VALUE ENGINEERING WORKSHOP REPORT (DRAFT)
for:
Florida Department of Transportation

South Sumter Trail
FPN: #435471-1

**RE: Value Engineering Study Report (Draft)
South Sumter Trail
FPN: #435471-1**

PROJECT:	South Sumter Trail FPN #: 435471-1	ALTERNATIVE NO.: S4-01
DESCRIPTION:	Build Curb And Gutter Rural Section To Avoid Ditch	SHEET NO.: 3 of 5

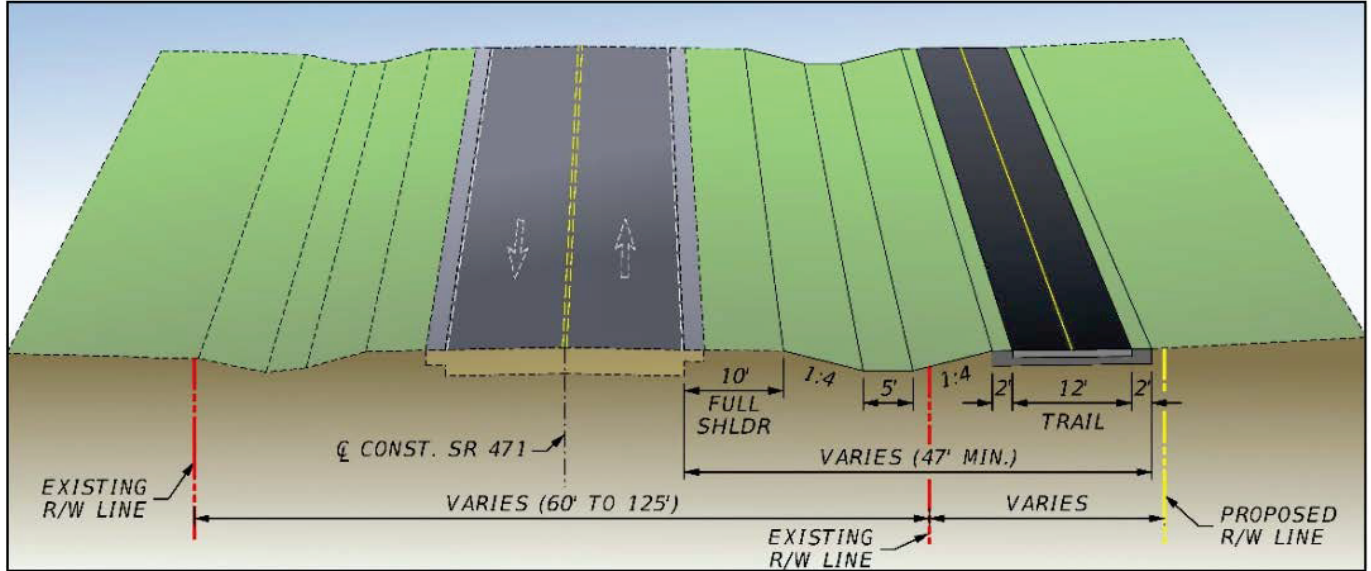
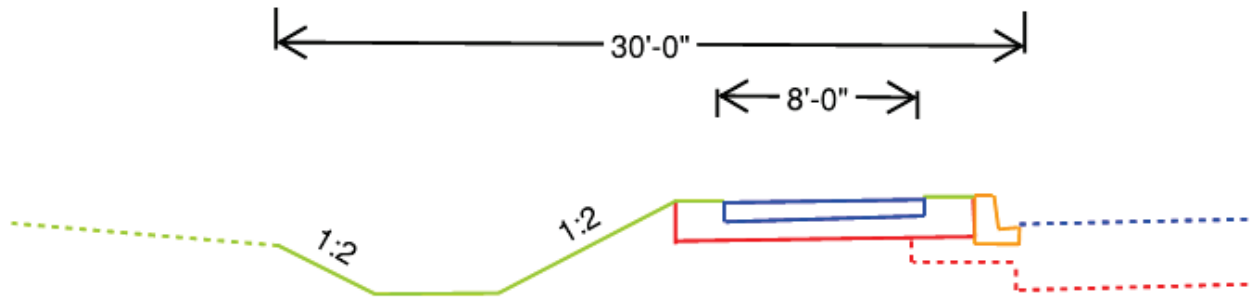
PROJECT:	South Sumter Trail FPN #: 435471-1	ALTERNATIVE NO.: S4-01
DESCRIPTION:	Build Curb And Gutter Rural Section To Avoid Ditch	SHEET NO.: 2 of 5
<p>TECHNICAL DISCUSSION:</p> <p>The rural typical section requires a further setback for the trail along SR 471. There are also large existing drainage features (offsite ditches) along this section that would be impacted if the trail was put between the road and ditch. Placing the trail on the outside of the ditch as shown in the typical section requires a larger RW strip take. Using a curb, the trail can be brought closer to the road and will fit with less impact to existing drainage. It will be necessary to place curb inlets to drain the system.</p>

PROJECT:	South Sumter Trail FPN #: 435471-1	ALTERNATIVE NO.: S4-02
DESCRIPTION:	Eliminate On Street Parking To Enable Curb And Trail Shift	SHEET NO.: 3 of 5

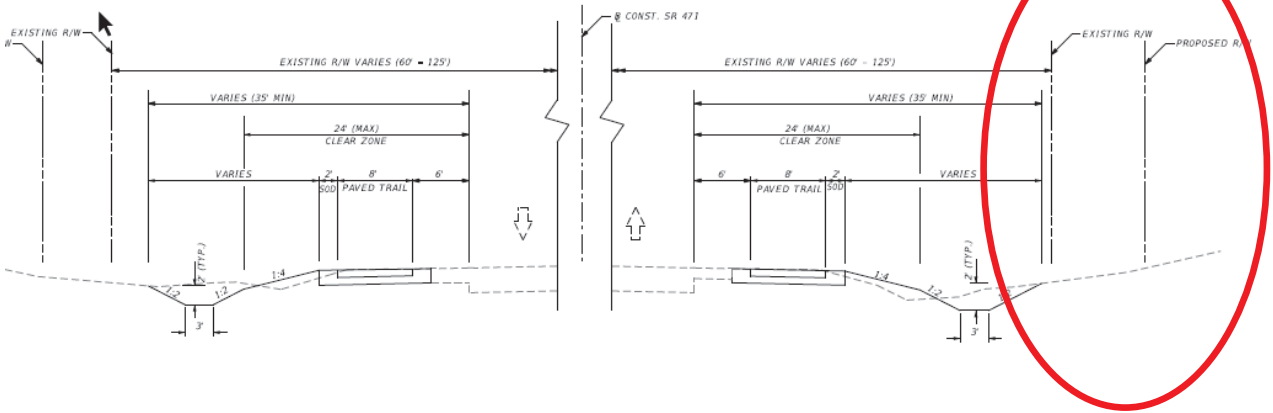
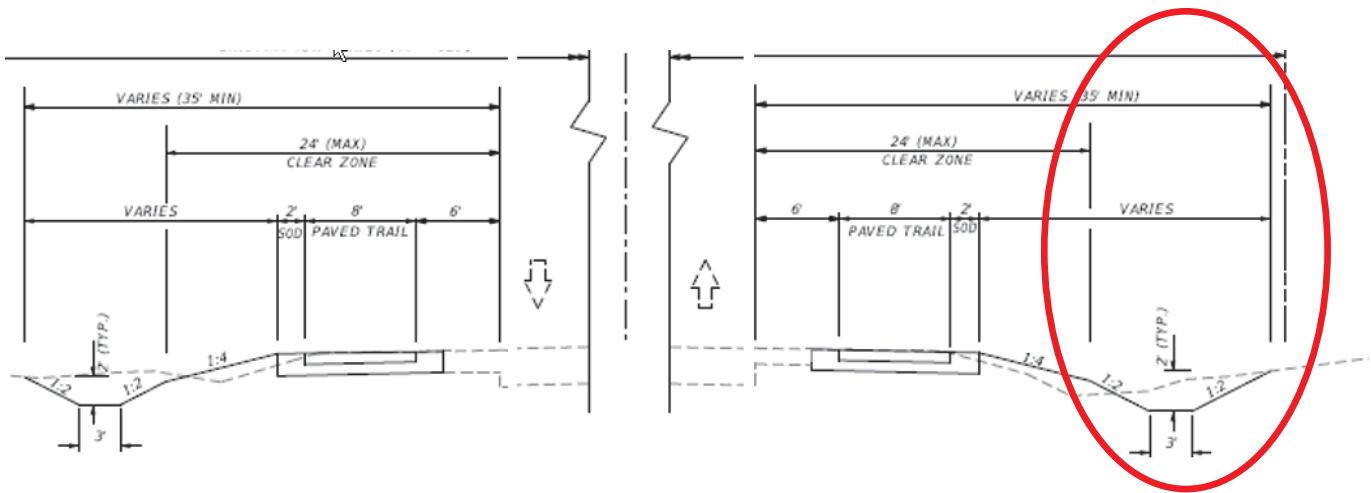
PROJECT:	South Sumter Trail FPN #: 435471-1	ALTERNATIVE NO.: S4-02
DESCRIPTION:	Eliminate On Street Parking To Enable Curb And Trail Shift	SHEET NO.: 2 of 5
<p>TECHNICAL DISCUSSION:</p> <p>This alternative will eliminate the on-street parking in Downtown Webster to increase the space within the right-of-way to complete the trail project. By moving the curb in 8' (currently the striped pavement and on-street parking) the trail will in-turn move an additional 8' providing portions of the roadway in which no right of way would need to be acquired.</p> <p>The VE Team observed no usage of the on-street parking during the field review and which allowed the team to make the presumption the space would be receive more activity if it was used to complete this gap in the Coast to Coast trail. To complete this suggestion the trail would serve as both a sidewalk and trail for the people of Webster.</p>

PROJECT:	South Sumter Trail FPN #: 435471-1	ALTERNATIVE NO.: S4-03
DESCRIPTION:	Use Pavers In Urban Section (PaveDrain)	SHEET NO.: 3 of 5

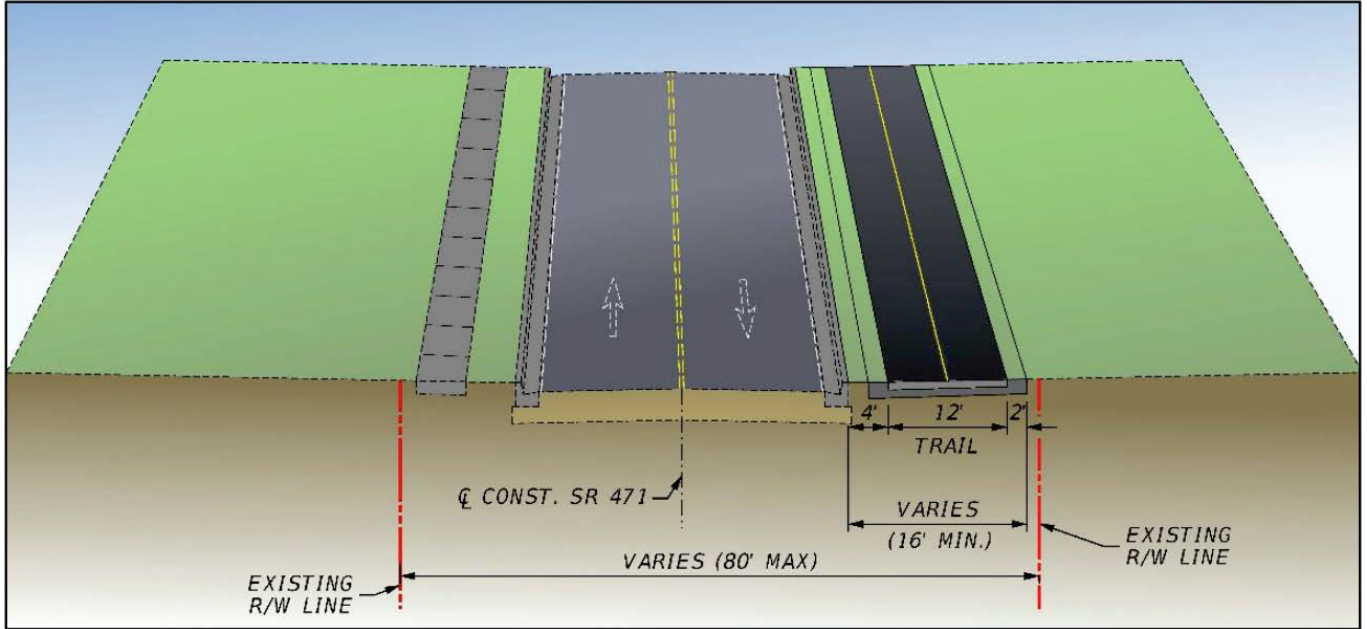
PROJECT:	South Sumter Trail FPN #: 435471-1	ALTERNATIVE NO.: S4-03
DESCRIPTION:	Use Pavers In Urban Section (PaveDrain)	SHEET NO.: 2 of 5
<p>TECHNICAL DISCUSSION:</p> <p>The asphalt trail will add impervious area. This will increase the runoff volume and flow rate received by the existing storm sewer system. This may require upsizing some of the existing infrastructure.</p> <p>Permeable pavement systems can reduce the runoff rate and would avoid having to upsize the existing system. The PaveDrain system is an example of a permeable pavement system that can achieve infiltration and also provides aesthetic enhancement to the area.</p>

PROJECT:	South Sumter Trail FPN #: 435471-1	ALTERNATIVE NO.: S4-04
DESCRIPTION:	Realign Trail Onto SR 721 South Of Webster To SR 50	SHEET NO.: 3 of 6

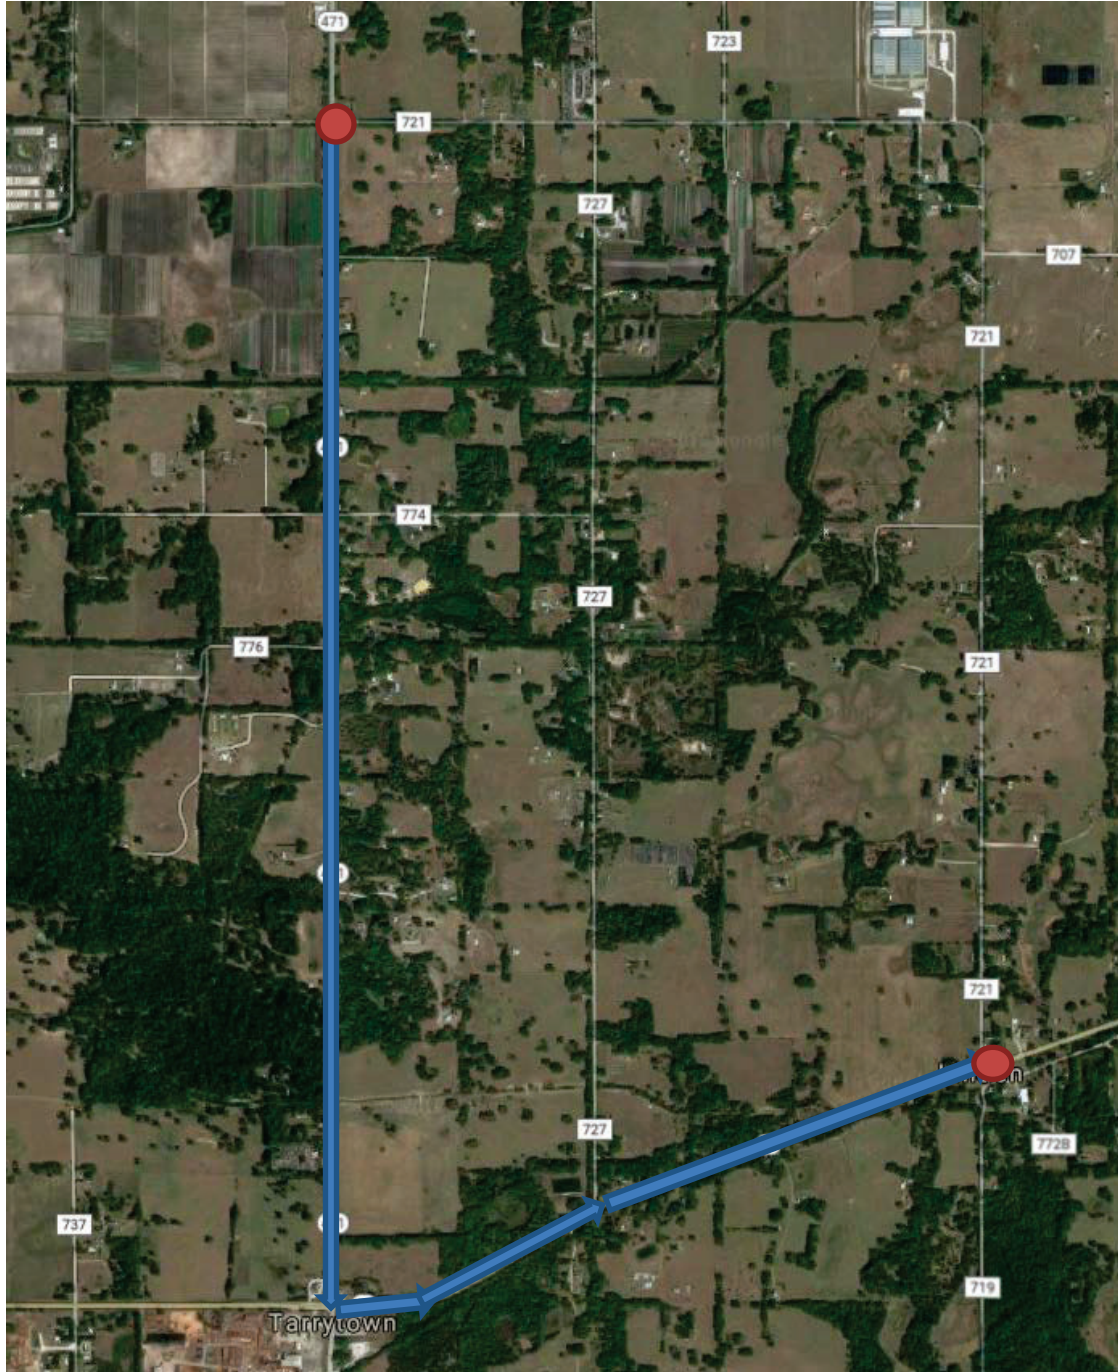
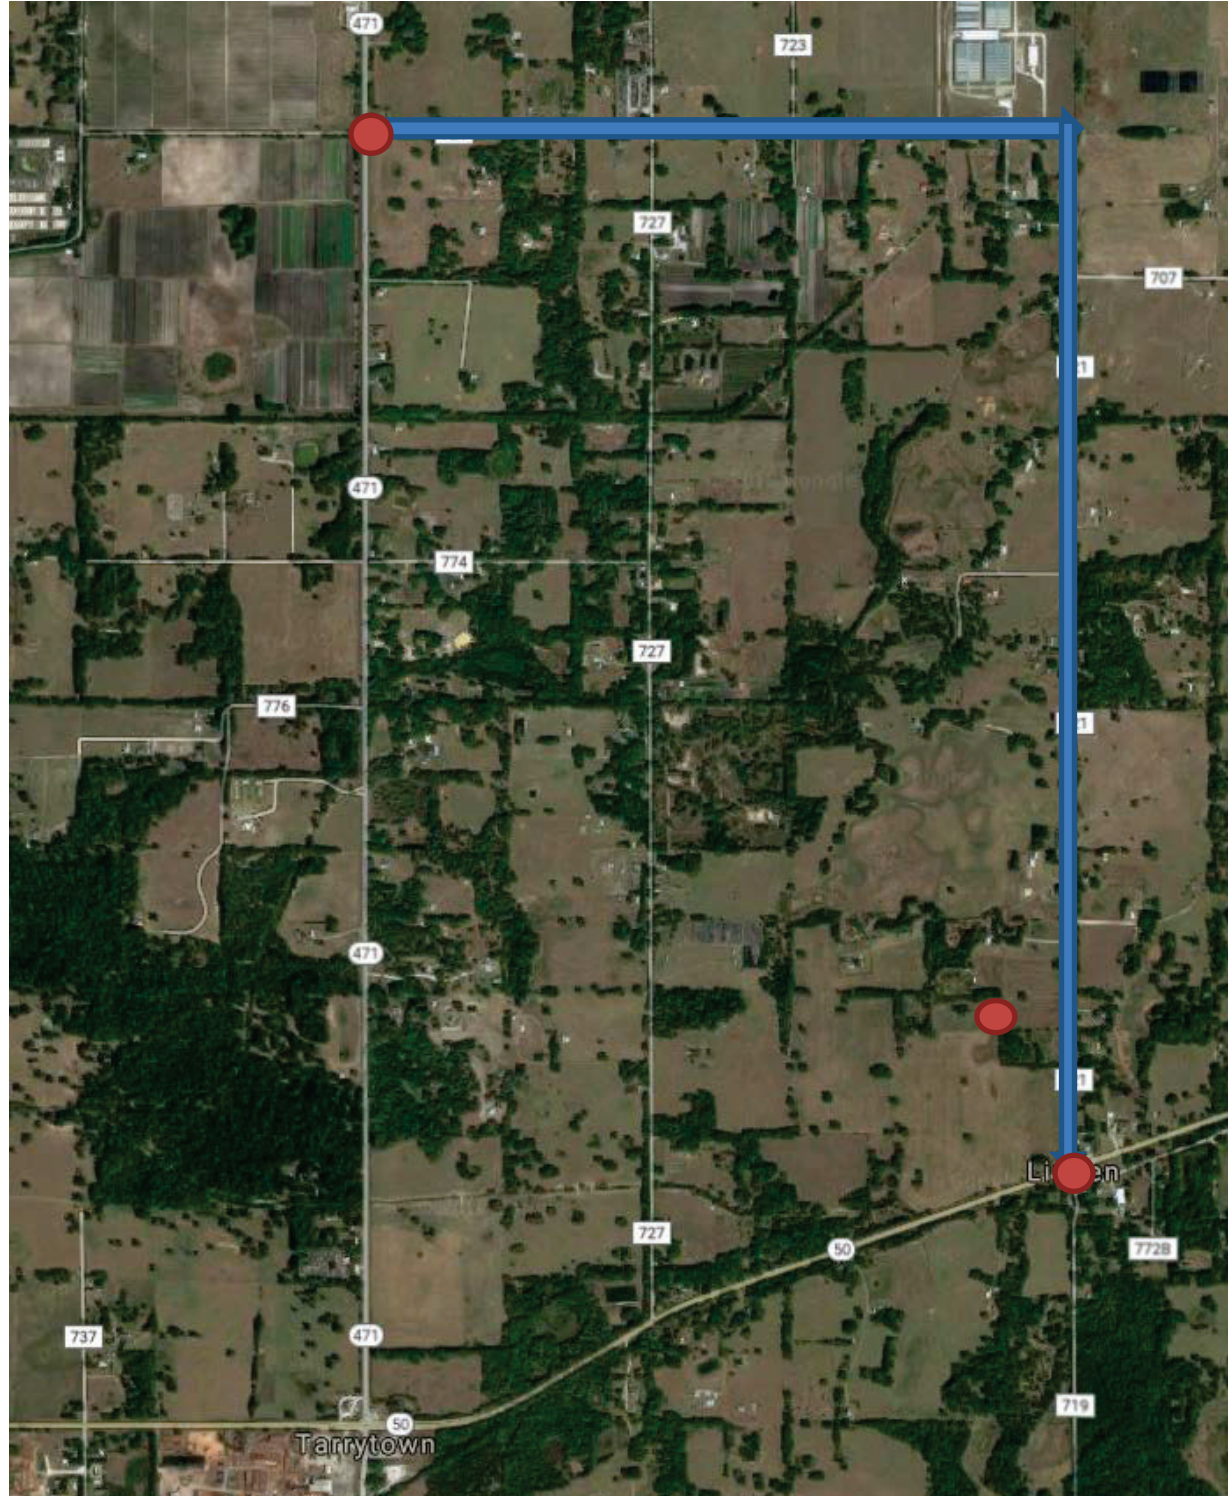
PROJECT:	South Sumter Trail FPN #: 435471-1	ALTERNATIVE NO.: S4-04
DESCRIPTION:	Realign Trail Onto SR 721 South Of Webster To SR 50	SHEET NO.: 2 of 6
<p>TECHNICAL DISCUSSION:</p> <p>This alternative involves a route that would bypass the commercial intersection at SR 50 and SR 471. The proposed alternative would route the trail along SR 721, which intersects SR 50 east of the planned intersection. This would be a slightly shorter route, and would provide a rural intersection for connecting trail users to SR 50.</p> <p>The original route would cover a length of approximately 3.6 miles to go from the intersection of SR 471 to the intersection of SR 50 and CR 721. The proposed alternative would require approximately 3.1 miles for the same locations. This would result in a reduction of .5 miles (2,640 linear feet) in construction costs.</p> <p>Additional costs for Right of Way are not possible to calculate without knowledge of road widths and design requirements along the proposed route.</p>

LENGTH: APPROXIMATELY 3.6 MILES

PROJECT:	South Sumter Trail FPN #: 435471-1	ALTERNATIVE NO.: SA-04
DESCRIPTION:	Place Ditch Outside Trail With Trail Adjacent To Roadway	SHEET NO.: 3 of 5

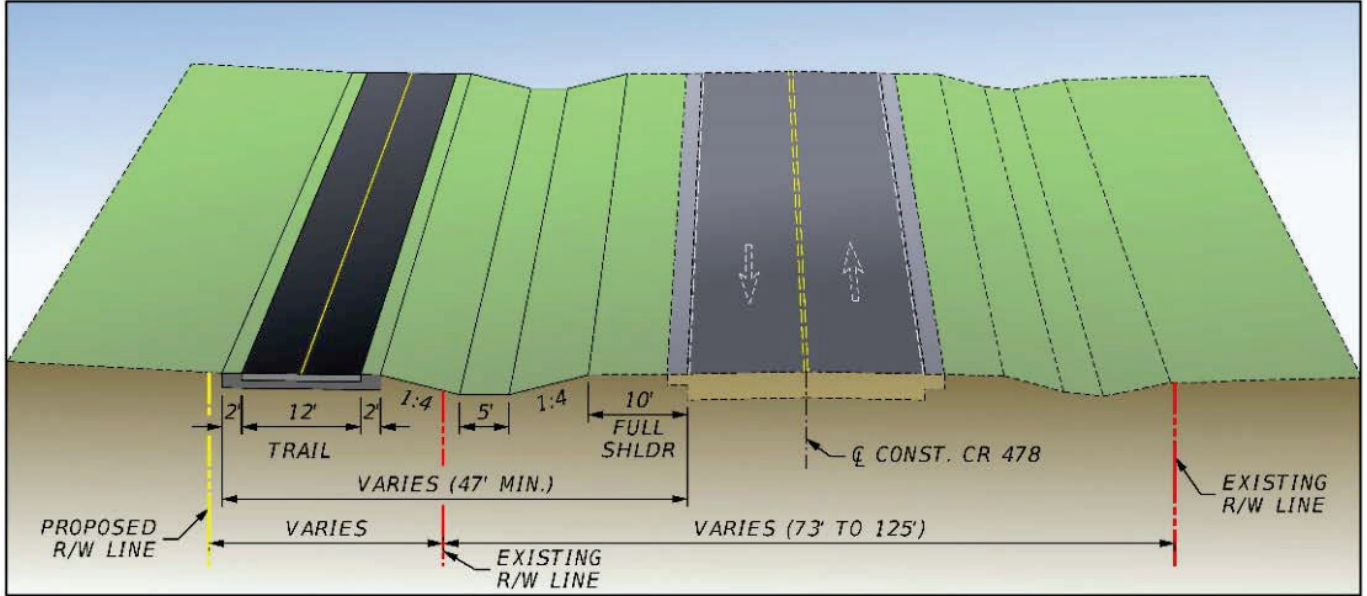
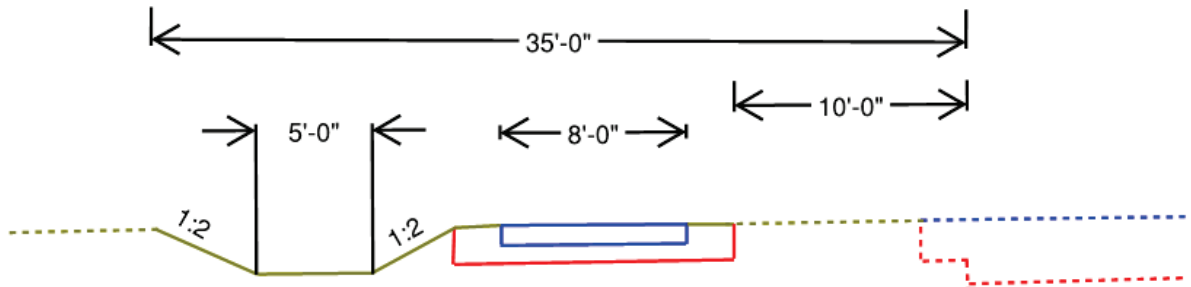
PROJECT:	South Sumter Trail FPN #: 435471-1	ALTERNATIVE NO.: SA-04
DESCRIPTION:	Place Ditch Outside Trail With Trail Adjacent To Roadway	SHEET NO.: 2 of 5
<p>TECHNICAL DISCUSSION:</p> <p>The current typical sections show a ditch between the roadway and the trail. The alternative to place the ditch outside the trail has several advantages. Since the ditch will be moved further from the roadway, the side slopes may be exempt from criteria requiring them to be recoverable. A 2:1 side slope for the ditches can be used to reduce the required RW width. In some areas this may aide in avoiding RW takes, and in other areas the reduced take may make negotiations with willing sellers easier. There will also be a reduction in the required earthwork.</p>

PROJECT:	South Sumter Trail FPN #: 435471-1	ALTERNATIVE NO.: SA-08
DESCRIPTION:	Bifurcate Trail To 8' Each Along Narrow ROW	SHEET NO.: 3 of 4

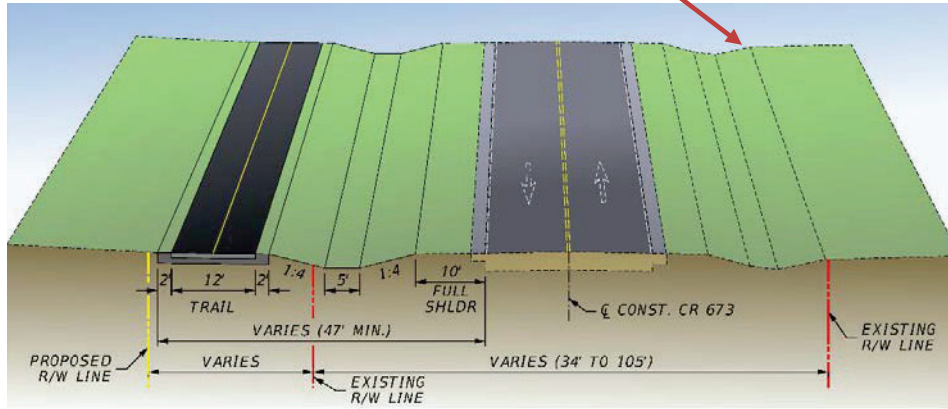
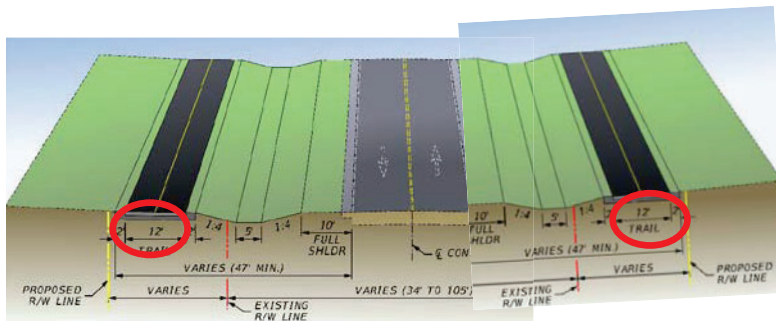
Note tight existing right of way

INTERMITTENTLY USED 8' SIDE PATHS WOULD OPERATE AS EASTBOUND AND WESTBOUND PATHS WITHIN THE EXISTING RIGHT OF WAY. POSITION COULD BE OUTSIDE OR INSIDE SWALE DEPENDING ON AVAILABILITY OF DIRT.

PROJECT:	South Sumter Trail FPN #: 435471-1	ALTERNATIVE NO.: SA-09
DESCRIPTION:	Safety Edge For Both Trail And Road	SHEET NO.: 3 of 4

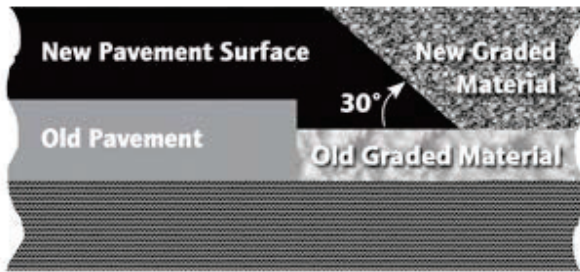
NO SPECIFIED PAVEMENT EDGE

PROJECT:	South Sumter Trail FPN #: 435471-1	ALTERNATIVE NO.: SA-10
DESCRIPTION:	Selectively Install Guardrail To Reduce Ditch Section	SHEET NO.: 3 of 5

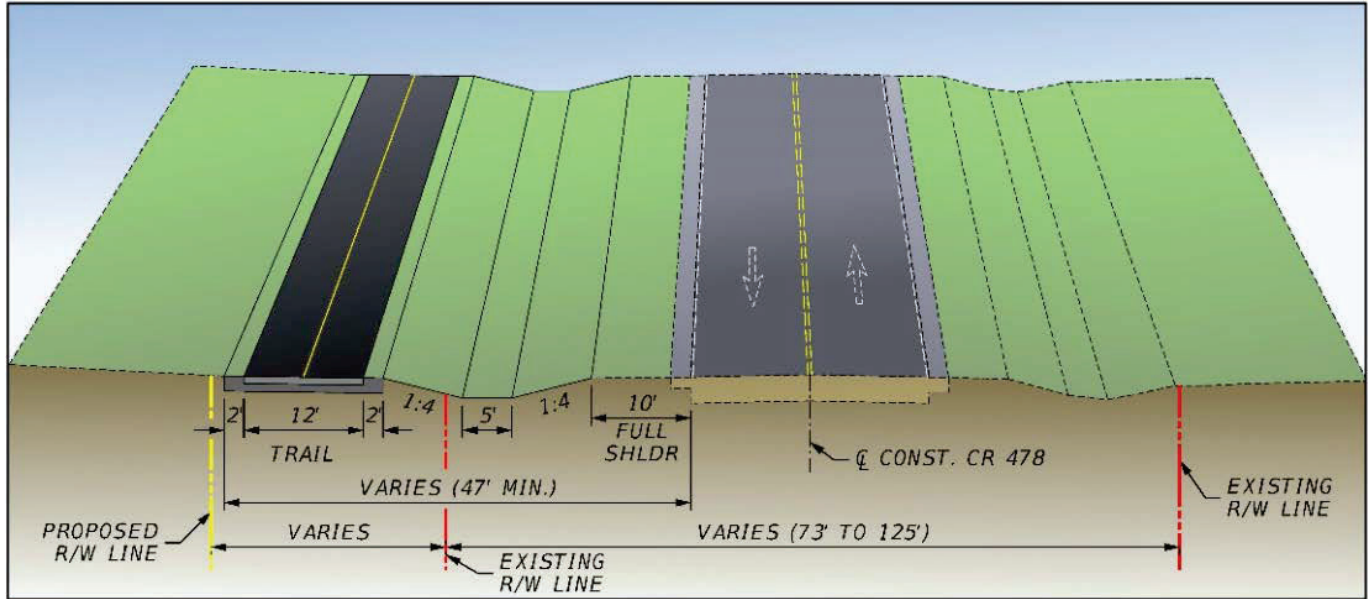
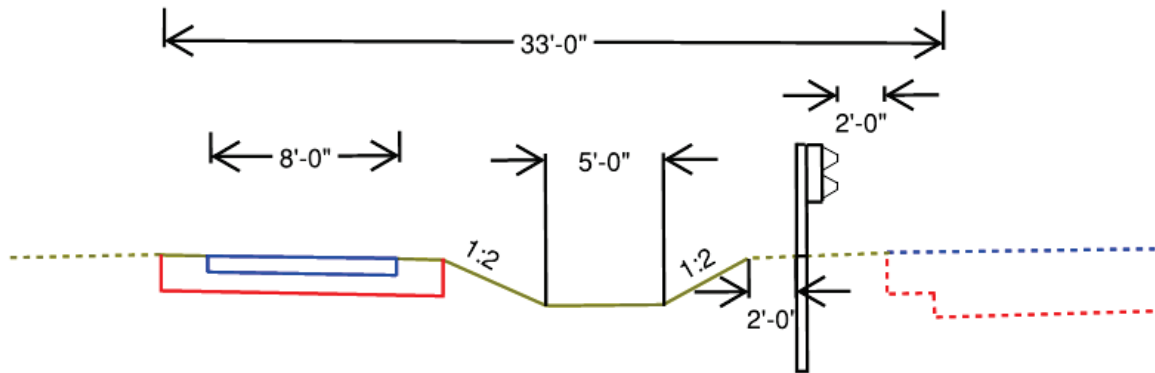
PROJECT:	South Sumter Trail FPN #: 435471-1	ALTERNATIVE NO.: SA-10
DESCRIPTION:	Selectively Install Guardrail To Reduce Ditch Section	SHEET NO.: 2 of 5
<p>TECHNICAL DISCUSSION:</p> <p>1:4 ditch side slopes are preferable along roadways for vehicle recoverability within the clear zone. Behind a guard rail, steeper slopes are permissible. A 1:2 slope behind a guard rail could be used on the ditch between the trail and road, or reconstruction of the existing ditch on the opposite side of the road from the trail in combination with shifting the roadway to avoid impacts to a property owner on the trail side.</p>
